Agenda Item: Fullwood Station Administrative Amendment

DATE: April 5, 2016
FROM: Mary Jo Gollnitz

RE: Fullwood Station – Administrative Amendment

**FULLWOOD STATION
 SINGLE-FAMILY SUBDIVISION**
 PROVIDENT LAND SERVICES, INC. | MATTHEWS, NC | MECKLENBURG COUNTY
OVERALL GRADING PLAN

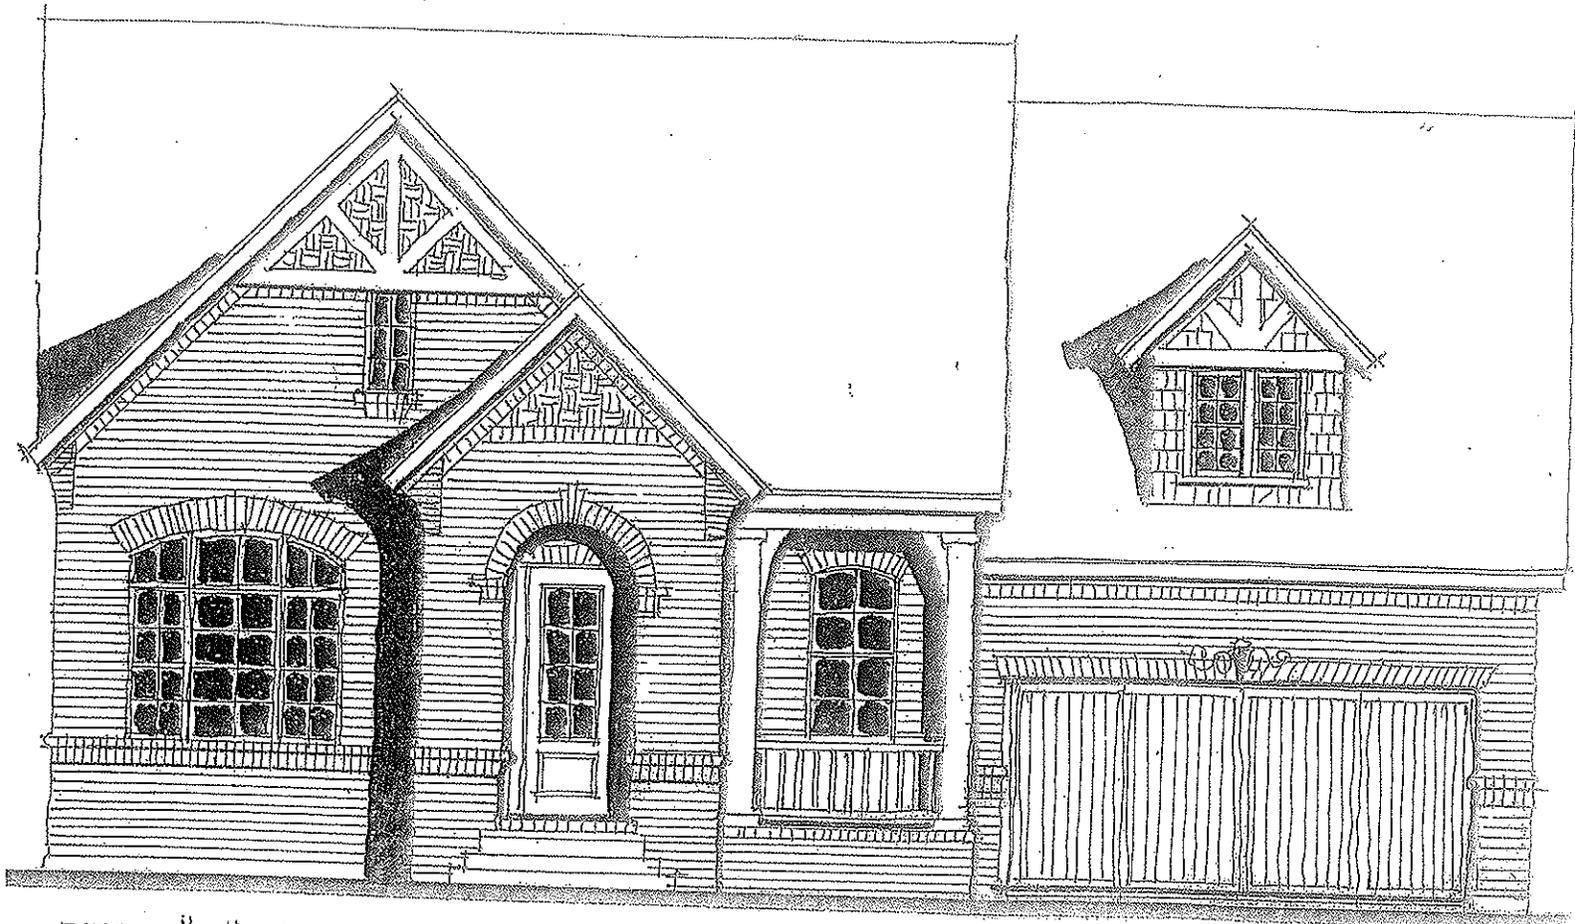
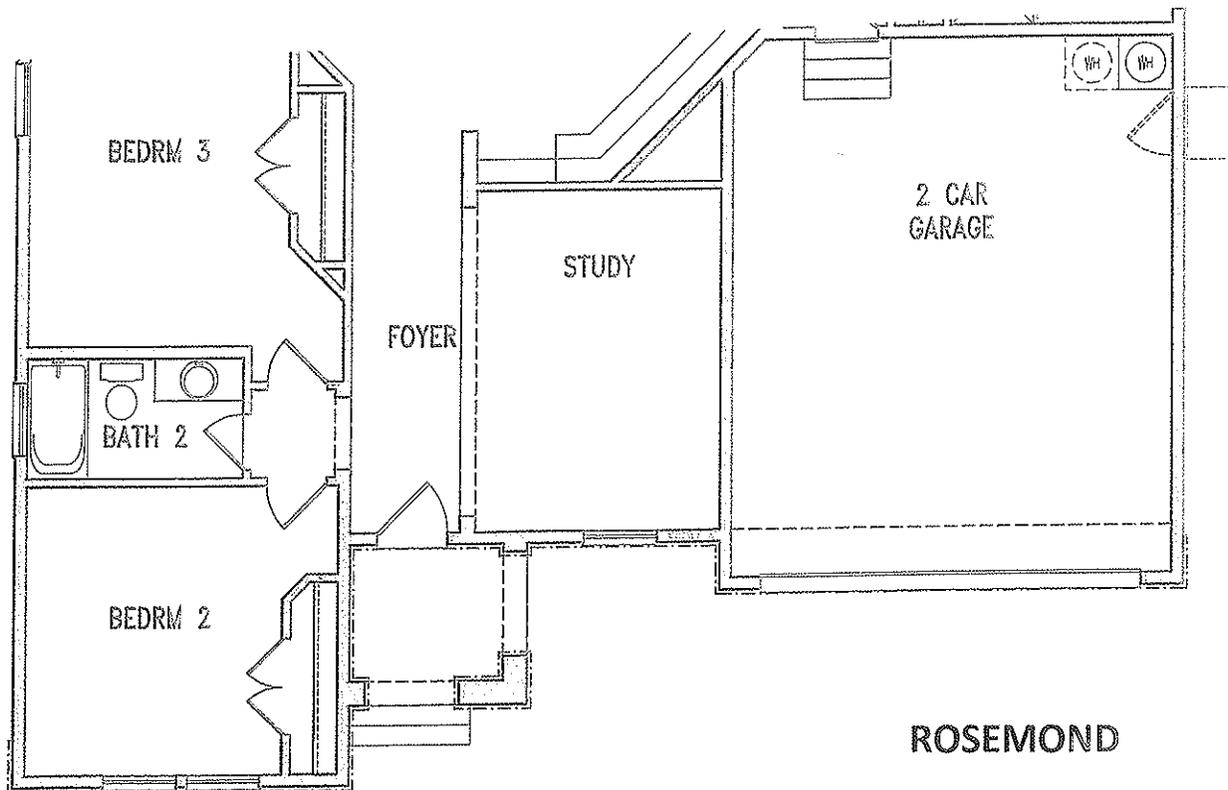
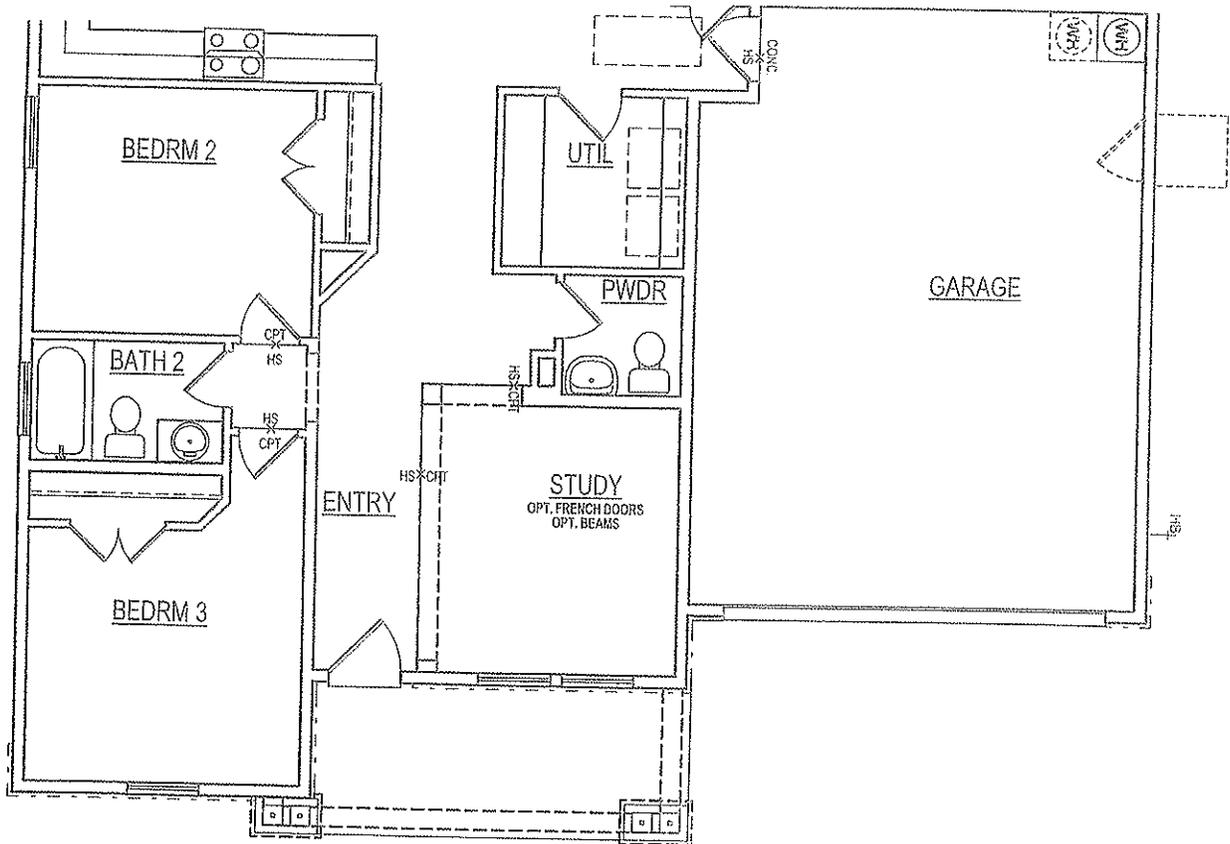
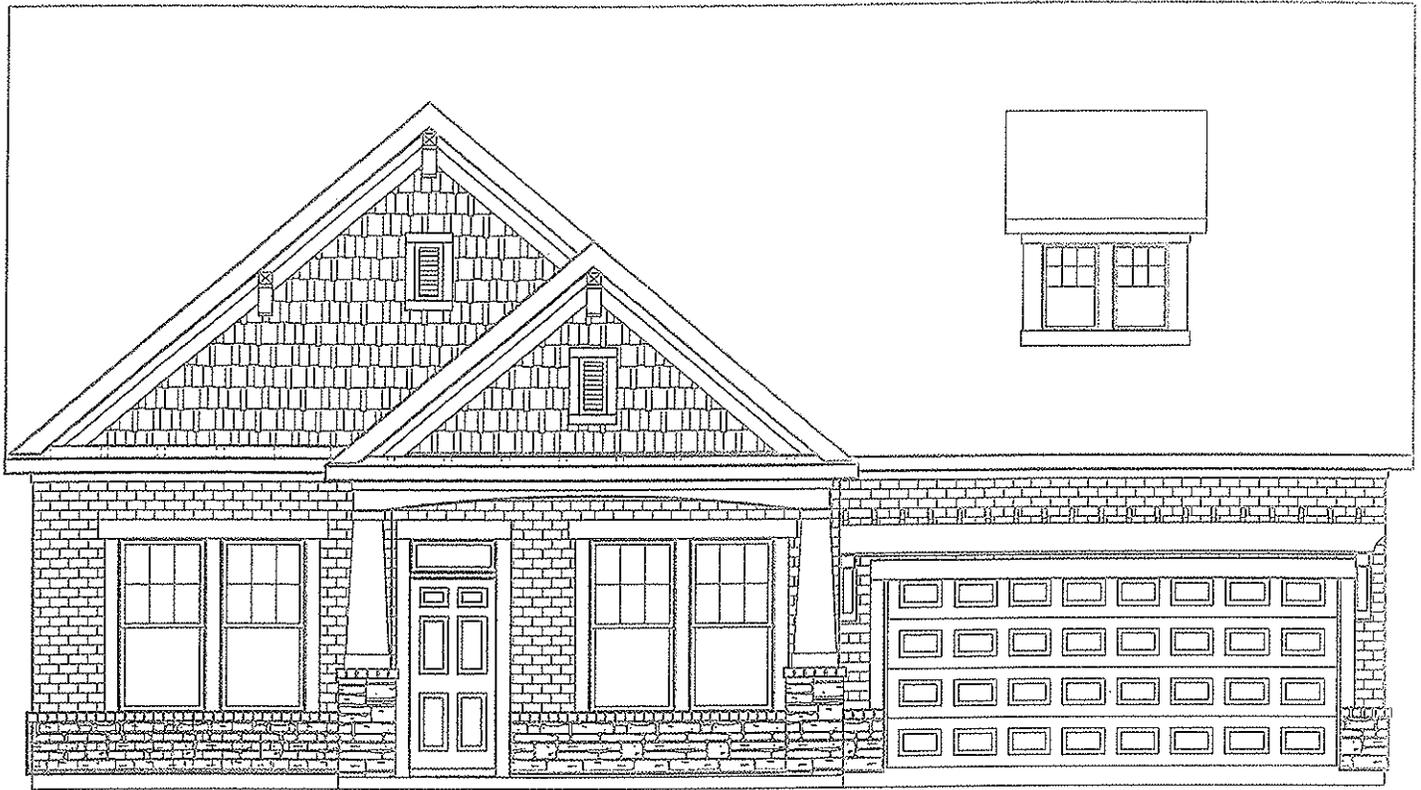
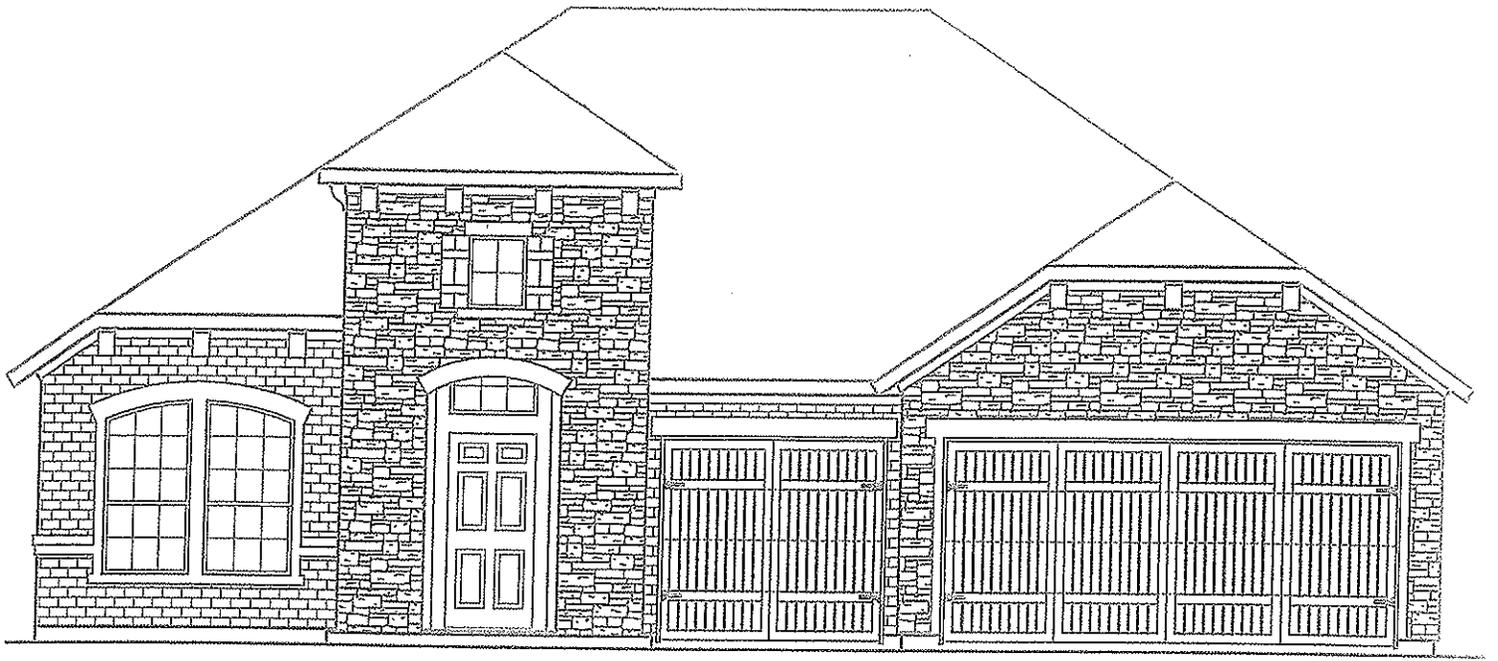
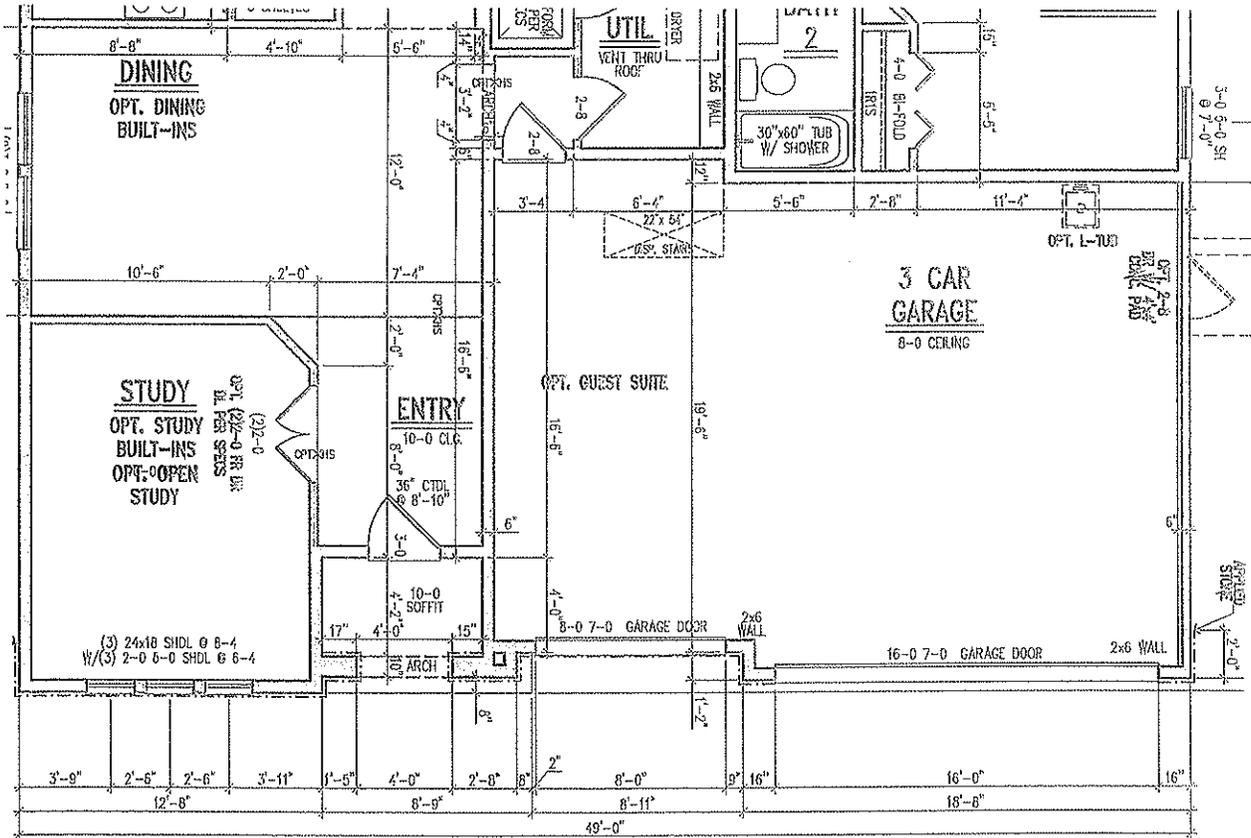
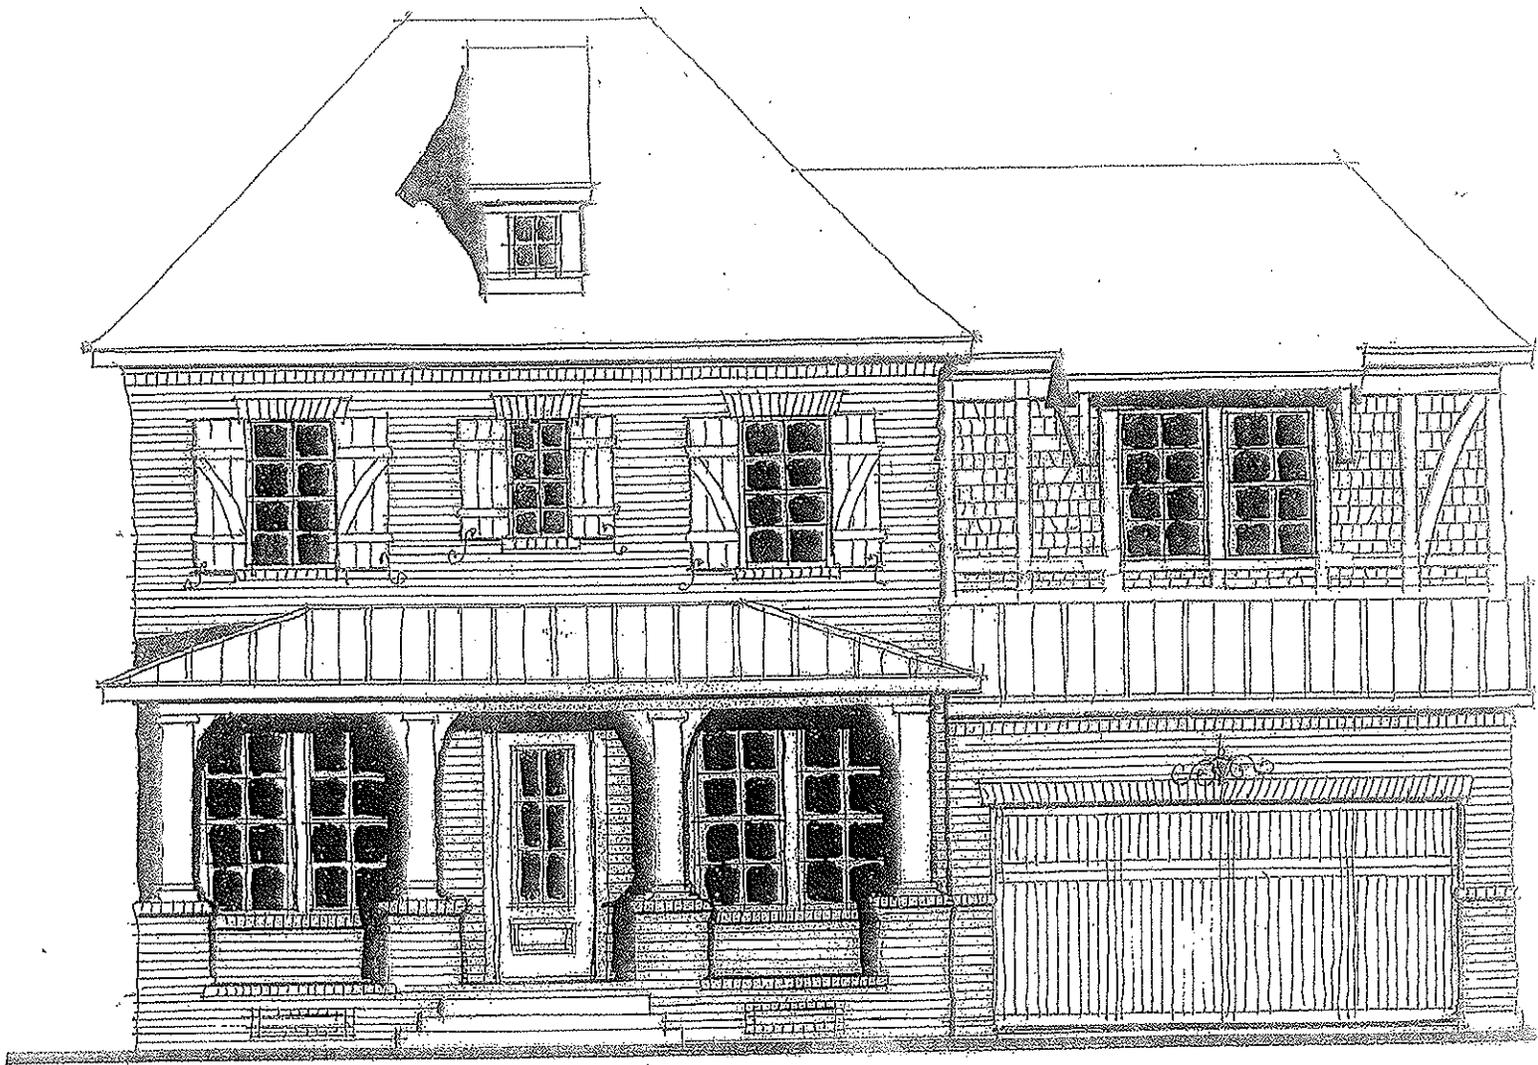
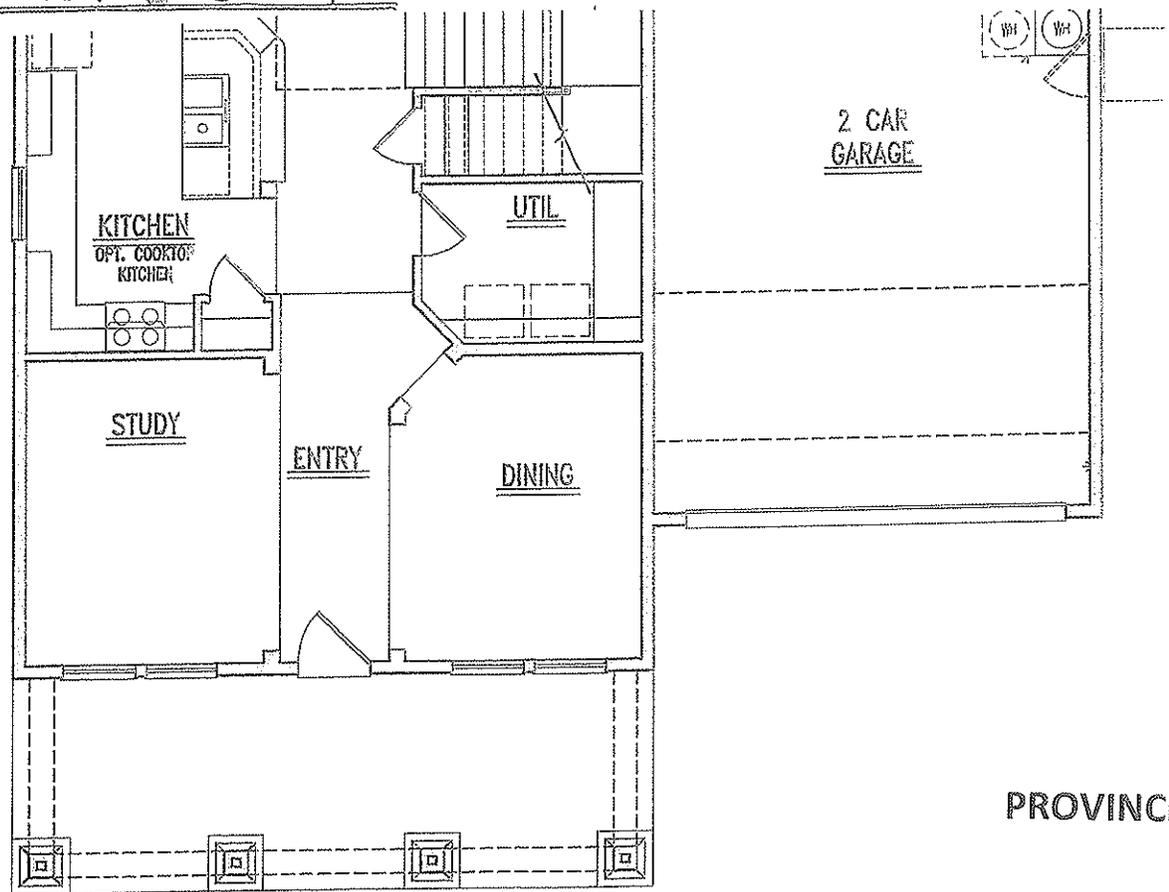
- A 6' sidewalk connection *“with steps out to S Trade St”* between Lots 5 and 6.
- Replacing previous house elevation illustrations due to a change in home builder.

6. Request to replace previous home renderings with new representative elevations provided by a new builder.

- 1 Provided house elevations make it difficult to determine if they all have four sided architecture agreed upon during the rezoning.
- 2 The trail terminus is positioned toward Woody Creek in order to provide a possible future connection to the greenway. Per the March 14 meeting discussion, the developer will provide \$2,940 funding for future connection. Price is based on 6' by 140' concrete path at current concrete pricing of \$3.50per square foot.
